Customer Advisory Notice CT057/20/S

**Force
Definition AS
Definition Edge
Definition Flash
Drive
Confidence
EdgePlus**

running syngo.CT VB20A_SP2

Subject: Technical issue with several SOMATOM CT scanners running on syngo CT VB20A_SP2, solved with the new service pack VB20A_SP3

Fig. 1: Context menu (right mouse click) offering the functions "Cut" and "Repeat" of a scan selected in the chronicle

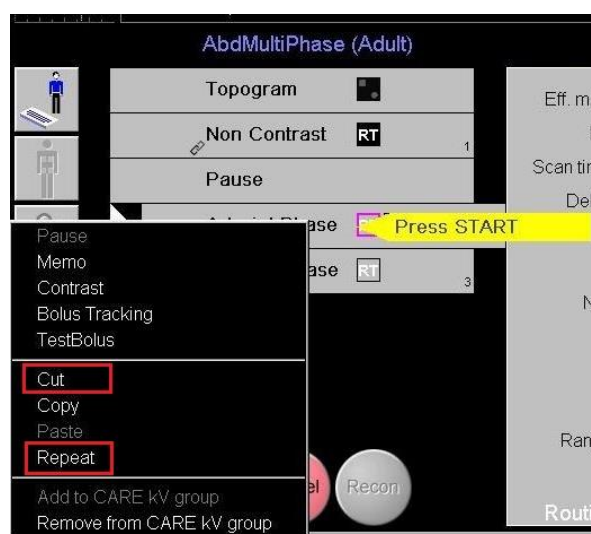
- A scan is loaded and the control box is flashing ("Press start" yellow message bubble is displayed) **and subsequently**
- A scan of the loaded protocol is cut or repeated (see Fig. 1)

In this situation it may be the case that the system will no longer accept any potential change to a scan or reconstruction-relevant parameter. Erroneously the changed parameters are displayed in the graphical user interface, but in fact the previous settings remain unchanged. Consequently, the original parameters will be used for the scan already loaded when the X-ray generation is started.

As the root cause, we found that the system does not trigger a cancel command followed by a reload of the scan with the new parameter(s).

Please cancel the scan already loaded **before** cutting or repeating an entry.

This issue will be solved by an improved syngo CT VB20A_SP3 software version. A service pack will be rolled out free of charge with the update CT056/20/S for all affected systems. Its release is planned for the end of Q4/2020. All future service packs will contain the fix as well.
